AGENDA
for the
REGULAR MEETING
of the
CITY of KINGSPORT
GATEWAY REVIEW COMMISSION

SUBJECT: **Begley Office Building on S. Wilcox: Final Plan and Certificate of Appropriateness**

PROJECT #: 13-105-00004

**PROPOSED SITE PLAN FOR
A NEW BUILDING BY BEGLEY BUILDERS
KINGSPORT, TENNESSEE**

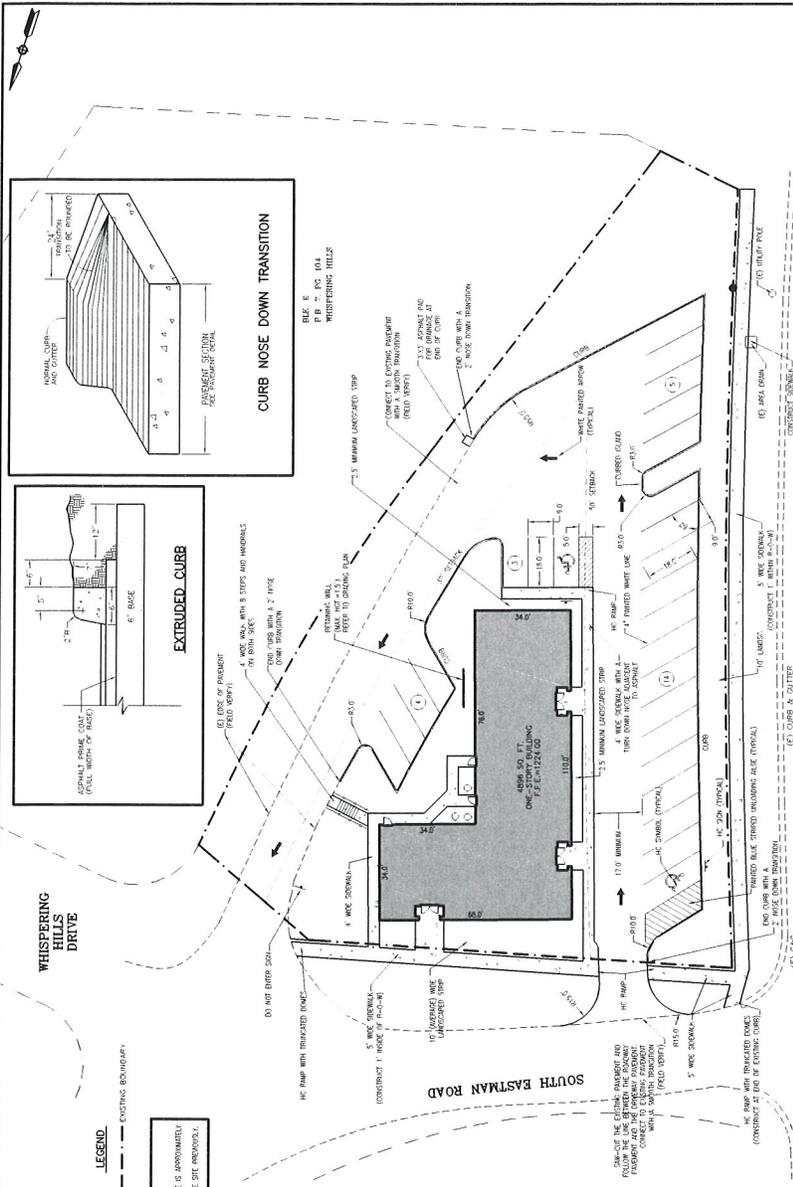
The proposed development is comprised of one-story "L" shaped building that is approximately 4,896 square feet in area for the main floor. Required setbacks in the B-3 district are 20 feet for the front yard, 0 feet for the side yard and 30 feet for the rear yard. The building meets the minimum setback requirements per Sheet C2. It should be noted that even though the side yard setback is zero feet, one side of the structure faces a public street and therefore must meet the required 10 foot wide landscape area which is on the South Eastman Road side and the Site Plan indicates this has been done.

Parking is regulated by the under lying zoning district requirements of the B-3 zone based on the use. Parking according to site plan will consist of 26 parking spaces with ingress/egress off of South Eastman Road. Ingress is via a one-way driveway and travel lane that is 17 feet wide and leads to 60 degree angle parking across the length of the site having 19 parking spaces. Of the 19 spaces, one is a van accessible handicap space. Parking spaces are 9'x18' with three more spaces located at the end of the building opposite South Eastman Road (one is handicap) and the rear of the building accommodates an additional 4 parking spaces adjacent to the one-way driveway that has egress onto South Eastman Road. The quantity of parking spaces exceeds the minimum code requirements of 4 per 1000 square feet. Parking lot surfacing as well as

travel lanes and ingress/egress driveways are indicated as asphalt. Sidewalks (5' wide) are placed in the public right-of-way along both streets as required.

Recommendation: Option 1 -

FRONT ELEVATION
 SCALE: 1/4" = 1'-0"

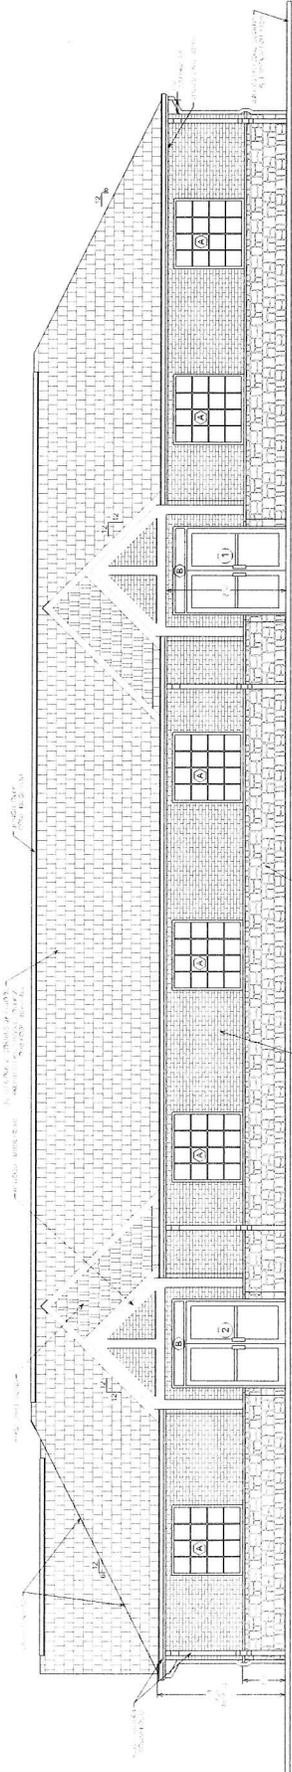
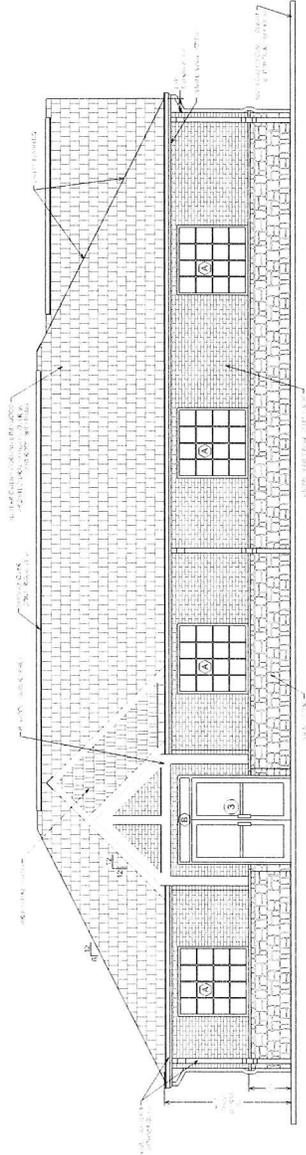
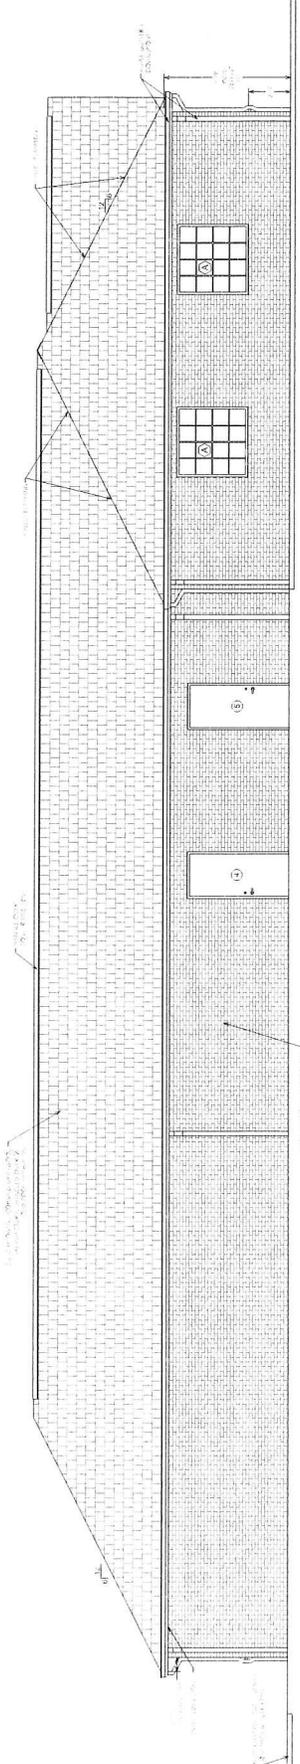
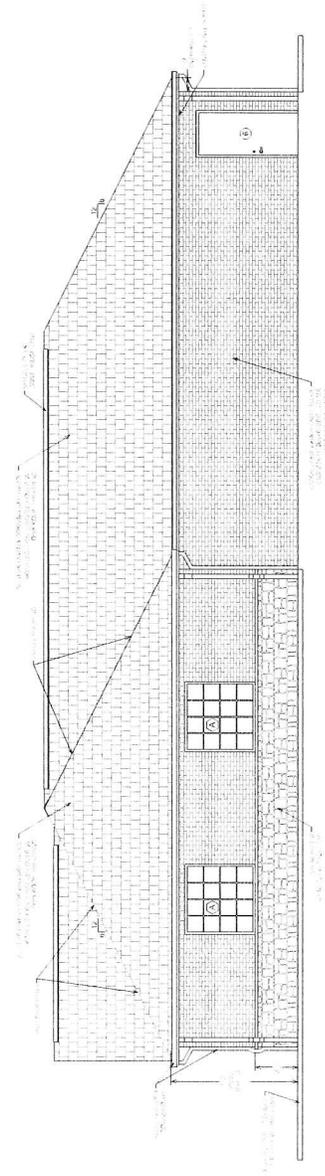
The front façade of the building will be brick veneer with two entrances that will have gable roofs over them. The walls of the entrances will consist of stone as will the base of the columns supporting the gable roof. Evidently there are two options being considered for the materials on the elevations. The first one consists of all brick veneer while the second one indicates a stacked stone wainscot approximately three (3) feet high to the base of the windows. Staff prefers the second option or the stacked stone mixed with brick as this is more in keeping with the Gateway intent to break up large expanses of the same material and offers a solid foundation to the appearance of the building. The roof will consist of a series of hips and gables with the two gables facing S. Wilcox and one facing South Eastman Road. The roofing material will be four-tab architectural shingles that are a tan and brown mix in color utilizing Oakridge Shingles in Driftwood with the bricks being General Shale-Walnut Creek Tudor. The windows and doors will be Pella aluminum with the door and mullions brick red in color. The siding and trim colors will be takeoffs of shades and tones of brown in Monterey Cliffs and Arrow Wood respectively with Arrow Wood being more of a taupe color. The overhang and gutters will consist of a russet color. Each entry is framed by a timbered gable roof structure that is supported by timber columns with a base of stacked stone with the timbers being stained Modern Walnut. The stone is varying shades of tan and beige in color.

Note: The developer has decided to go with the combination stone and brick veneer elevations as indicated in the packet so the all brick veneer elevations have been removed. Only the rear elevation will consist of all brick veneer.
